THE RESIDENCES AT ECHELON
Lee's Summit, Jackson County, Missouri

WATER PLAN & PROFILE
Construction Plans for:
THE RESIDENCES AT ECHELON
Lee's Summit, Jackson County, Missouri

C.503

WATER PLAN & PROFILE

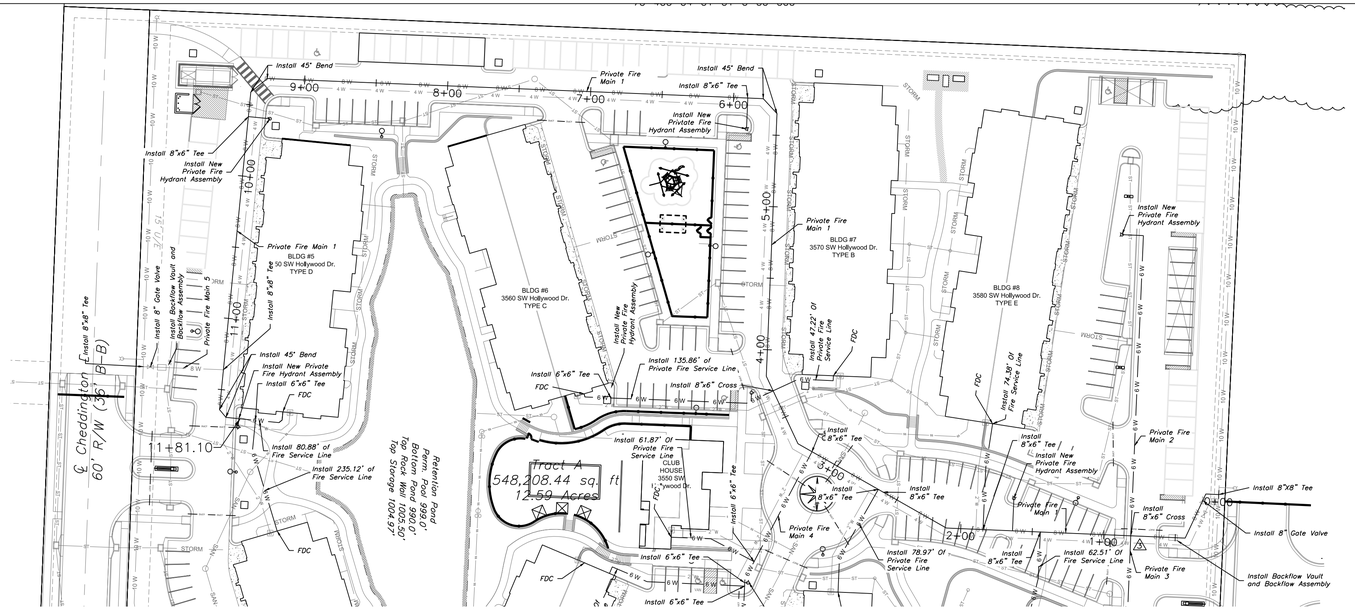
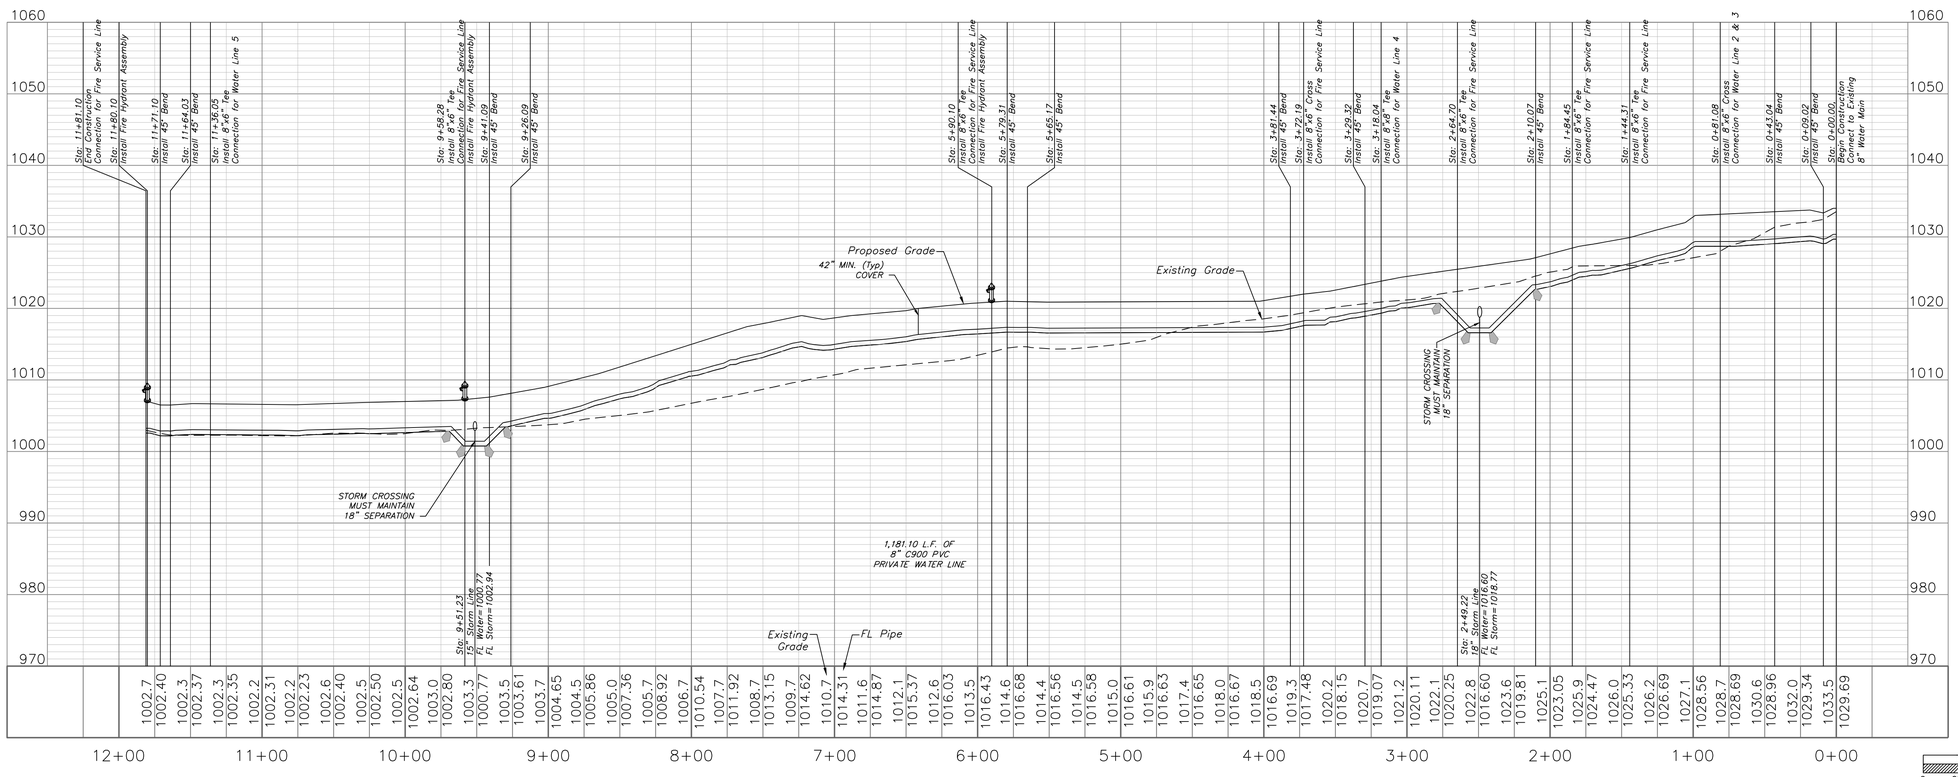
Engineering Review
2. Labeled the sanitary and water lines as private as requested.
14. Removed the cover sheets for the private water and sanitary.
17. Provided locations for the domestic water lines as requested.

Planning Review
3. Reconciled Water Line 1, 2, and 3 locations.

Engineering Review
31. Water Lines have been altered to provided a separate Fire Line and Public Line.
32. 2" Water Meters are being used for this project and are located near the buildings.
33. Provided note stating that the public lines along Cheddington Dr. and Hollywood Dr. are part of a separate construction set.
34. Changed the note stating the use of 6" fire line shall be DIP shall not be used for this project.
35. Removed the note stating to tap the fire line.
36. Reconciled the fire lines and the domestic lines to be separated.
37. Relabeled the profiles as requested.
38. Provided utility crossings in the profile views.
39. The color scheme is due to the printer malfunctioning.
